L62X-  
R.03.24

To: After Sales Official Network  
Subject: crash relevant bracket assembly  
Date: 31/10/2024  
Pages: 4

**Campaign code:**  
L62X-R.03.24

**Campaign name:**  
crash relevant bracket assembly

Figure – Incorrect Assembly (Case 2)

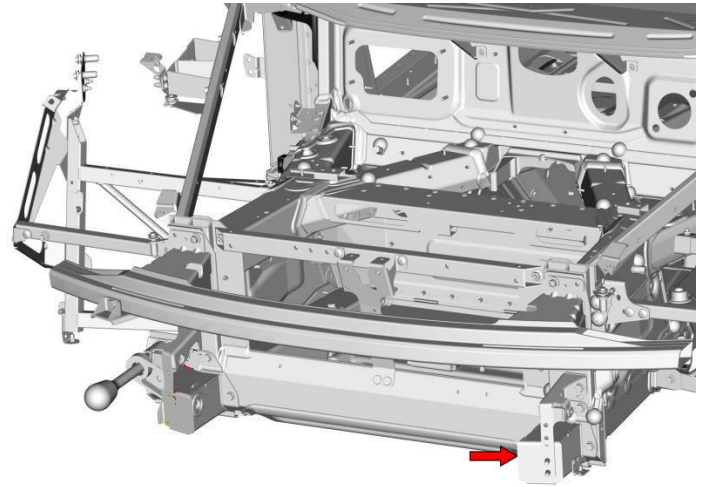
**CASE 2 – Bracket on the left side**

If the bracket is mounted on the left side (wrong side - Figure 2), the bracket must be disassembled and reassembled correctly on the right side (correct side).

To do this, follow these steps:  
Select correct car: Huracan-->Spyder-->LP640-4-Evo Spyder-->MY24  
Follow the path:  
Body--> Frame-->Front--> Structural Components of Front Frame 1-->803.01.26-Front Chassis Brace

Figure 1 – Correct Assembly (Case 1)

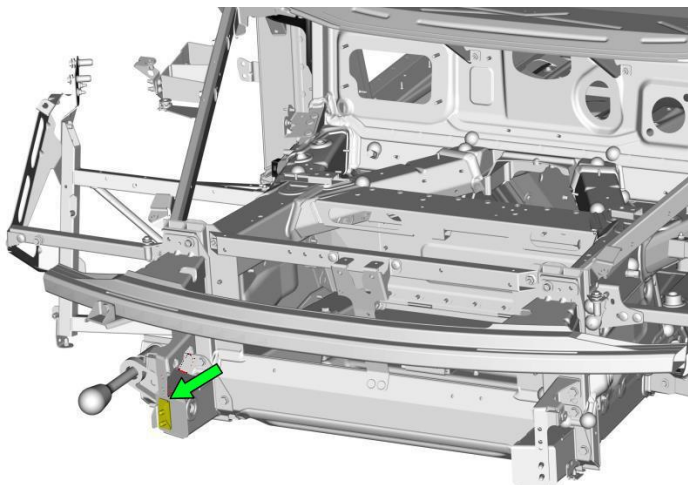
**CASE 1 – Bracket on the right side**

If the bracket is correctly located on the right side (Figure 1), the car can be reassembled by following the final steps.
